ASSESSMENT REPORT

TAHMOOR NORTH MINE

REDBANK RAIL TUNNEL DEVIATION MODIFICATION (DA 67/98 MOD 2)

Figure 4: Sensitive receiver locations

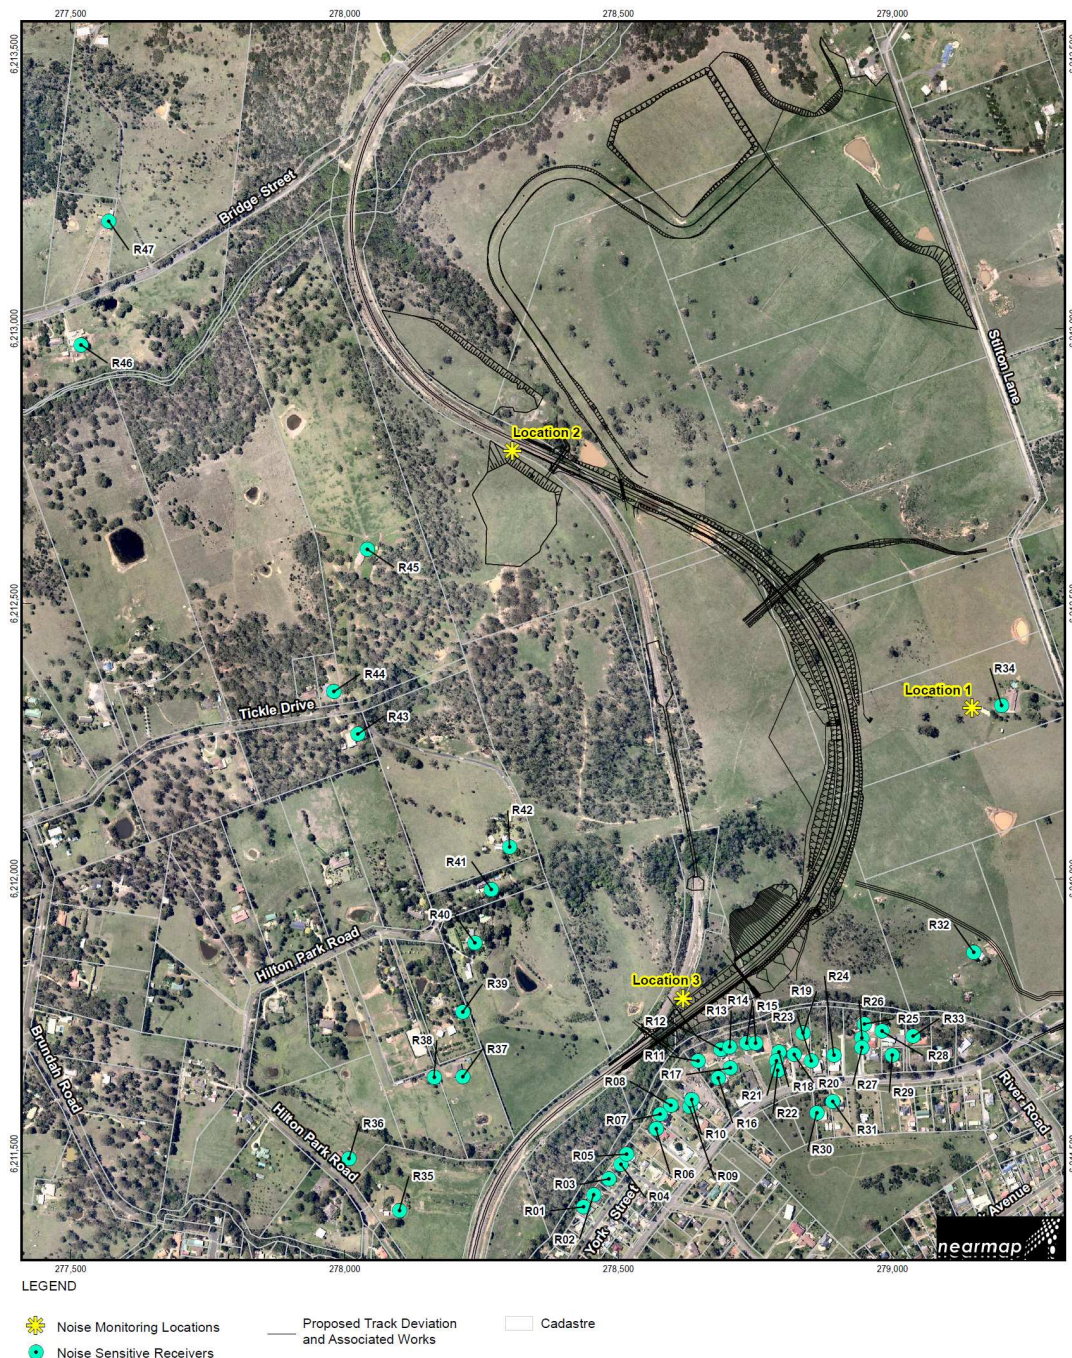
To assess construction noise impacts, the NIA estimated equipment noise levels at distances ranging from 50 m to 1000 m from the construction site. The results indicate that 70 residences are located within 1000 m of the site, and that they have potential for noise to exceed the ICNG's "noise affected" criteria during standard construction hours. These ICNG criteria are intended to reflect the point above which there may be some community reaction to construction noise. The NIA also found that it is unlikely that the ICNG's "highly noise affected" criteria would be exceeded at any residences. These criteria are the level above which the ICNG judges that there may be strong

The NIA also includes procedures for Tahmoor to respond to high levels of construction noise, particularly outside of standard construction hours. These procedures reflect a standard matrix of responses included in the Transport Construction Authority's *Construction Noise Strategy* (2010). This matrix includes a monitoring program and additional mitigation measures, ranging from compliance monitoring and letterbox drop notifications through to alternative accommodation options. The standard matrix proposes that monitoring would take place at the commencement of construction, as well as monitoring at residences that exceed 20 dB(A) above the relevant RBL during standard construction hours and evenings, and at residences that exceed 10 dB(A) above the relevant RBL for Sundays and night-time.

However, the Department considers that construction noise is better managed through appropriate restrictions on construction hours, rather than implementation of monitoring requirements which only come into play at substantial exceedances of RBLs. Consequently, it has recommended conditions which would limit construction hours to standard hours, except at the request or direction of the Australian Rail Track Corporation (ARTC).

The Department has also recommended a condition requiring Tahmoor to submit a Construction Noise Management Plan (CNMP) for the rail deviation, prepared in accordance with the *Construction Noise Strategy*, for approval by the Director-General prior to commencement of significant construction work on the deviation. The CNMP would have to describe the noise mitigation measures to be implemented to minimise noise impacts from construction activities, set out an appropriate noise monitoring program and outline the procedures to manage responses to any complaints or issues raised by noise-affected residents.

To address the possibility of construction noise impacts outside of standard construction hours, the Department has also recommended a condition requiring Tahmoor to undertake a community consultation process and associated mitigation measures in accordance with the *Construction Noise Strategy* (ie to also implement the standard matrix of measures referred to above).

Figure 5: Cross section of proposed noise barrier options

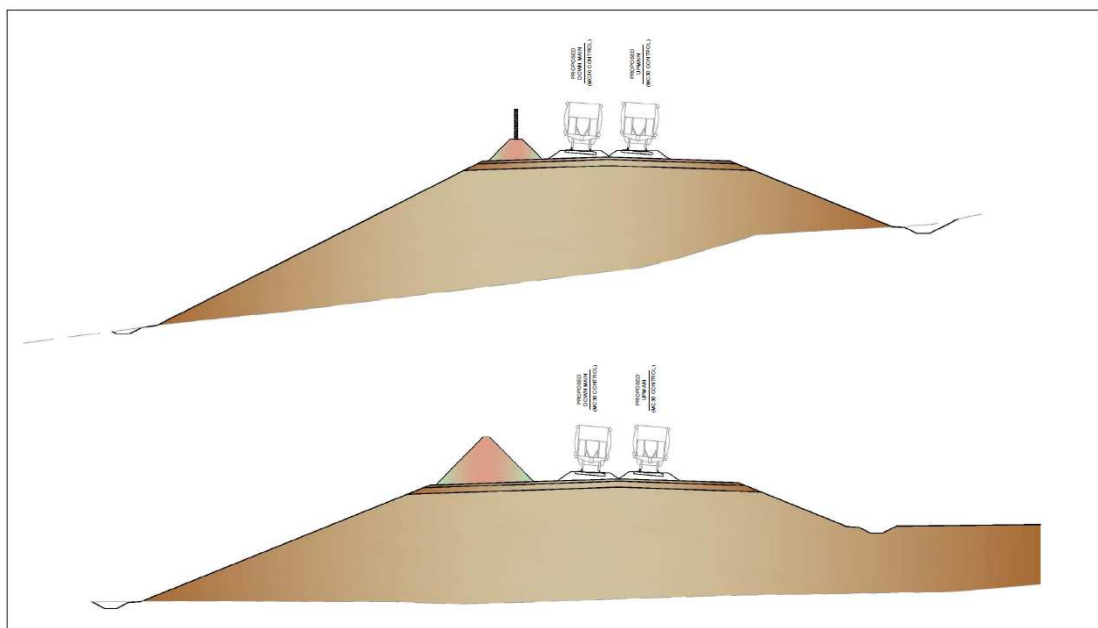
The NIA compared predicted noise impacts on residential receivers from the operation of the existing and proposed rail route, in accordance with the IGANRIP. This assessment was based on noise mitigation measures proposed to be incorporated into the design of the proposed rail route, including a 2.4 m high noise barrier on the southern side of the deviation (refer to **Figure 5**).

The results of the assessment found that resultant rail noise would actually *decrease* at 40 of the 47 receivers, as a result of the proposed modification, primarily due to the construction of the noise barrier. Receivers where noise levels were predicted to increase are shown in **Table 2** below, with increased noise levels shown in red. Six of these seven affected receivers are predicted to have increases of not greater than 1 dB(A), which is inaudible to the human ear. Receiver R34 is predicted to experience a significant increase in noise levels as a result of the modification. However, the higher level is well within the IGANRIP criteria for new rail line developments, and well below the noise levels experienced at the other six affected receivers.

The Department notes the concerns raised in the public objection about the effectiveness of the proposed sound barrier. The Department's acoustic specialist has carefully considered the proposed barrier design and predicted noise levels from rail operations. The Department is satisfied that a decrease in rail noise levels would occur at the majority of receivers as a result of the proposed noise mitigation measures, and that the great majority of the remaining receivers would only experience a negligible increase. Therefore, the Department is satisfied that the predicted noise levels would not have a significant impact on surrounding sensitive receivers.
